FIELD CHANGE REQUEST (FCR) FORM

Project Name: Arkema Project Area – PDI Phase 2
Client: LSS/Retia USA

Project No.: CF16Z
Request No.: FCR-17

Field Change Request Title: Vibracore Step-Outs into the Navigation Channel.

FIGURE 1	
March 30, 2022

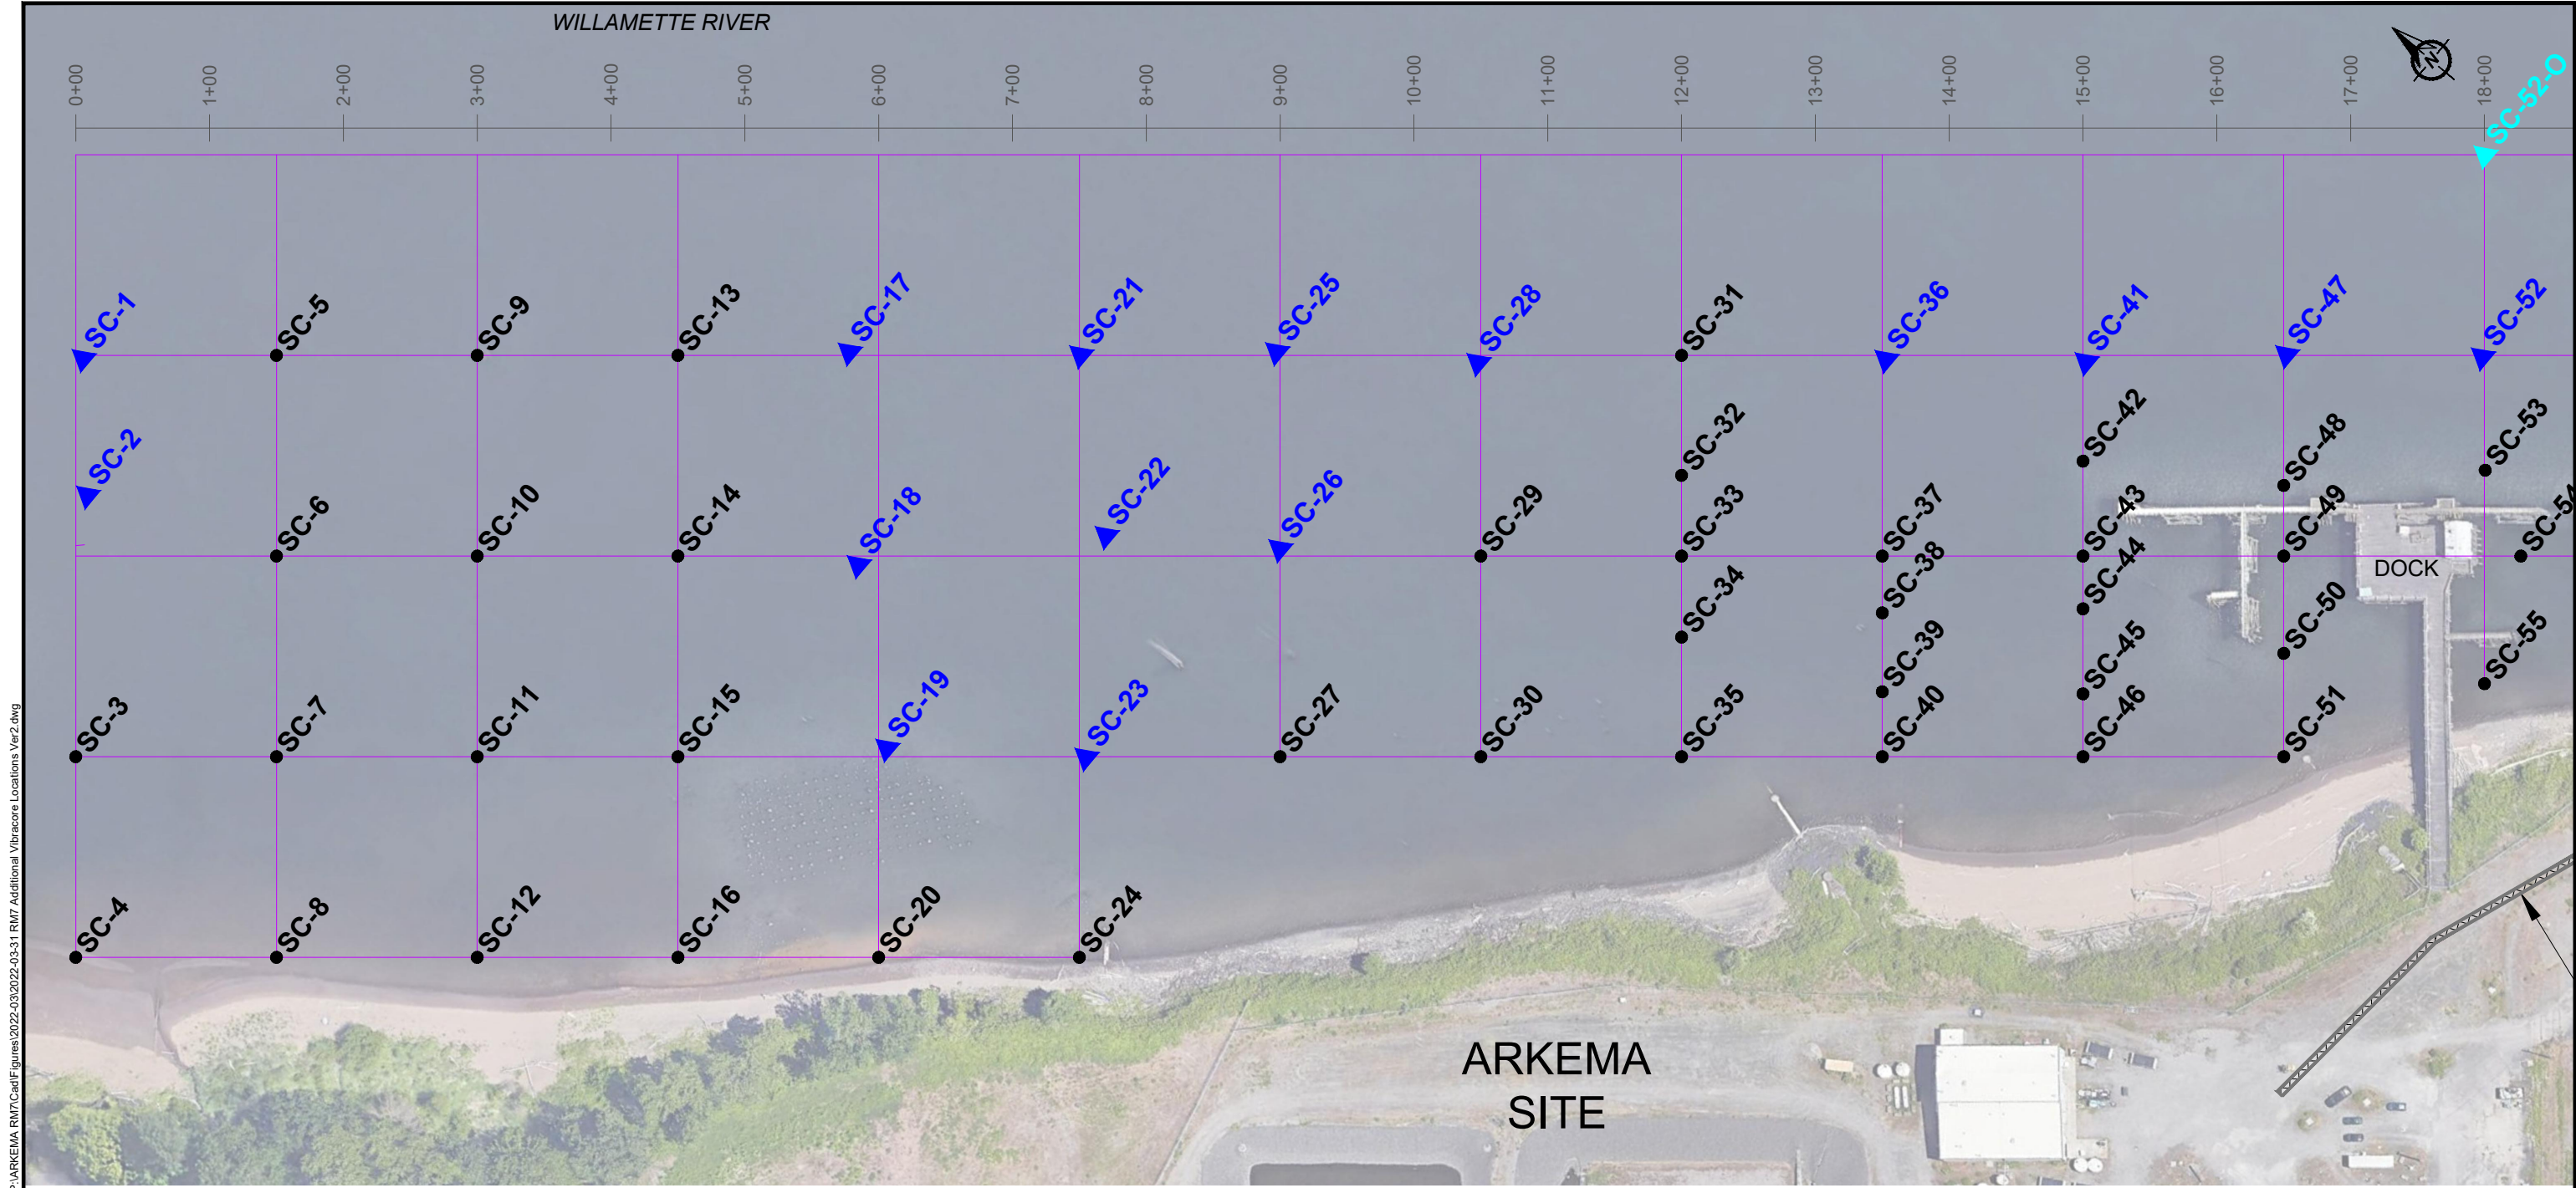
Phase I sediment vibracoring was conducted at 39 stations in November/December 2021. All sediment samples collected in the Dock 1 and 2 Reach were analyzed for chlorobenzene (because of short VOC analysis hold times) to determine the vertical distribution of chlorobenzene in sediment. Other sediment samples are being analyzed sequentially using the sediment sample analysis decision tree as a guide (Figure 3-2c of the Arkema Project Area Pre-Design Investigation (PDI) work plan). Remediation thresholds were exceeded for chlorobenzene in sediment samples on the farthest most riverward row of sediment cores, at stations SC-52, SC-56, SC-60, SC-64, SC-67, and SC-70. Chlorobenzene remediation threshold exceedances were bracketed to the north and south at sediment cores SC-47 and SC-72, respectively. However, another row of sediment cores is needed to delineate the lateral extent of remediation threshold exceedances to the east of the above referenced core locations.

Another row of sediment vibracore stations is recommended toward the river channel. The additional stations are shown on Figures 1 and 2. The additional stations (SC-52-0, SC-56-0, SC-60-0, SC-64-0, SC-67-0, and SC-70-0) will be advanced and sampled to 19 ft bml or to sampler refusal using the protocol developed in the approved PDI work plan (Section 4.5.1 of the Field Sampling Plan (FSP), Appendix A to the PDI Work Plan) and related approved FCRs, as needed. Each 1-ft interval from these cores will be analyzed for chlorobenzene by EPA Method 8260C in accordance with the PDI Work Plan. Depending on the chlorobenzene results from these additional core locations, additional step-out cores may be completed in accordance with this FCR procedure with the goal to laterally and vertically delineate chlorobenzene concentrations in sediment in the Dock 1 and 2 Reach. If additional cores are recommended, the locations will be provided to EPA for approval with a reference to this FCR.
